BZAP - WORK SESSION

1/4/2023 6:00 PM

Subject: Informal review of a proposed two-story garage addition.

Property Owner/Address: Hicks, 2380 Northwest Boulevard (zoned R-1c)

SITE PLAN

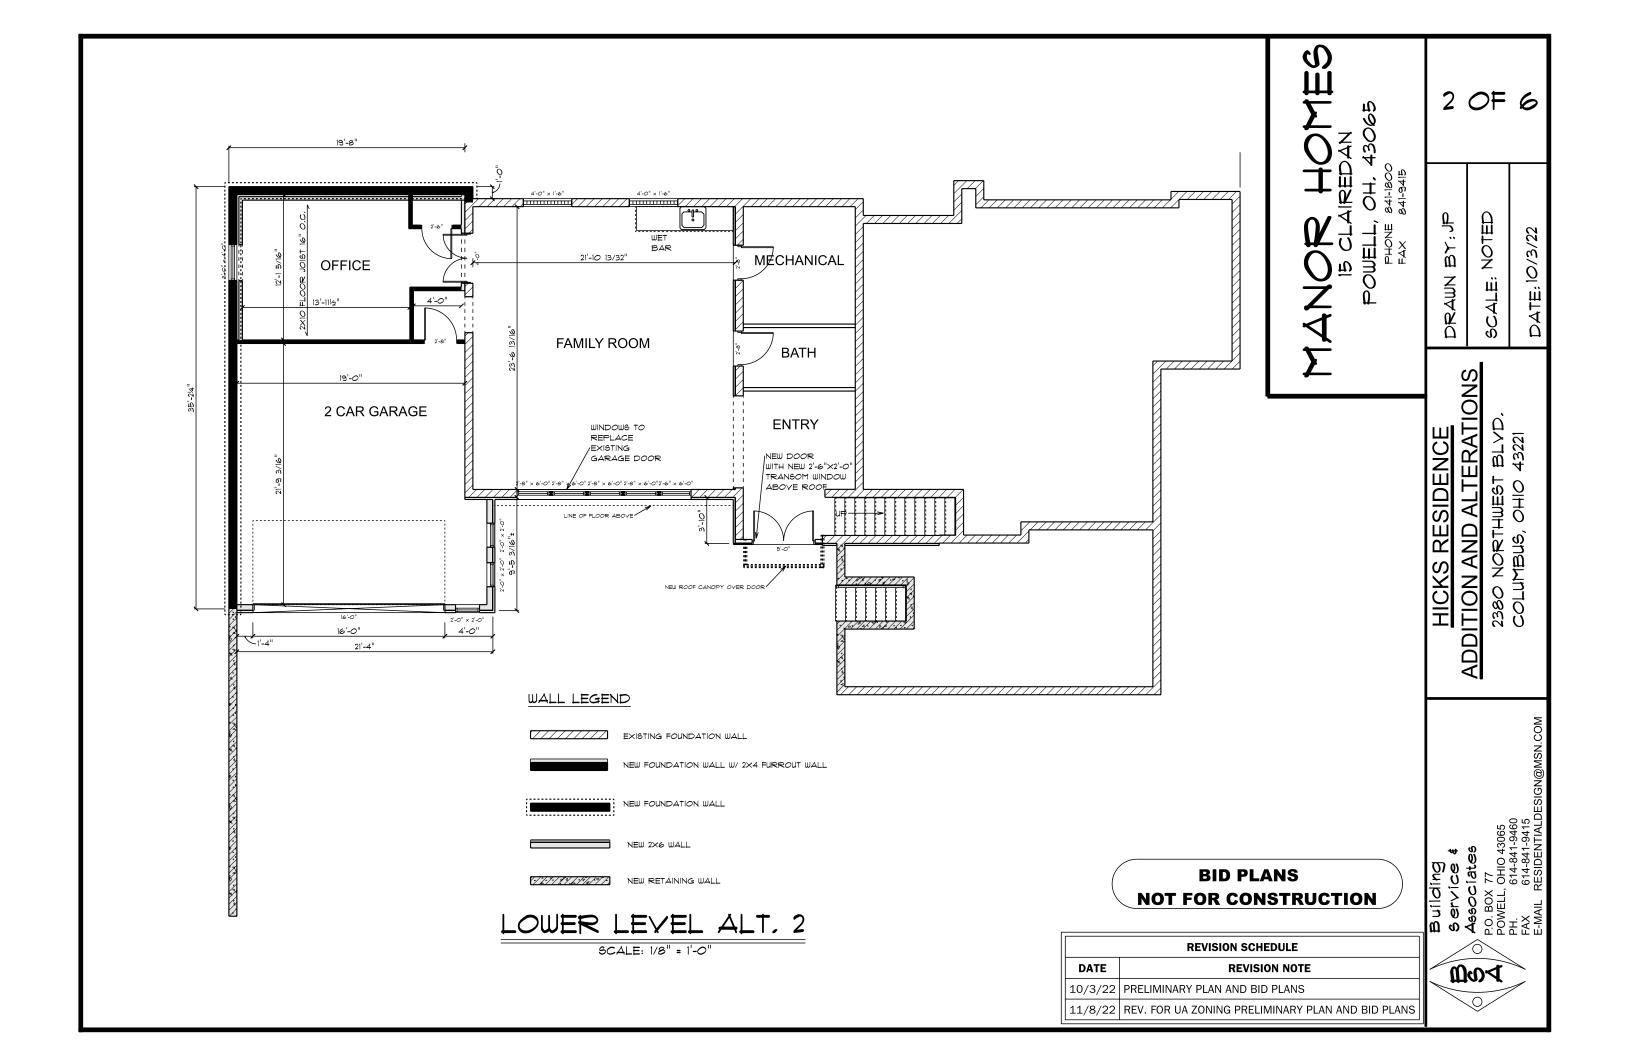
At its closest point, the addition would be 5'-10" from the east (rear) property line and 8'-10" from the south (side) property line, where each required setback is ten feet (*variances required*). A rear profile encroachment of 5'-2" is also proposed. The applicant previously explored a plat amendment application before reconfiguring the plan to the current proposal, which the applicant noted is the minimum necessary.

- To UDO Article 5.02 to permit a two-story addition to encroach up to 4'-2" into the tenfoot minimum rear yard setback;
- To UDO Article 5.02 to permit a two-story addition to project up to 5'-2" into the rear profile;
- To UDO Article 5.02 to permit a two-story addition to encroach up to 1'-1" into the tenfoot side yard setback; and
- To UDO Article 5.02 to permit a two-story addition to encroach up to 7'-2" feet into the side yard longwall setback (when a side yard elevation exceeds 40 feet).
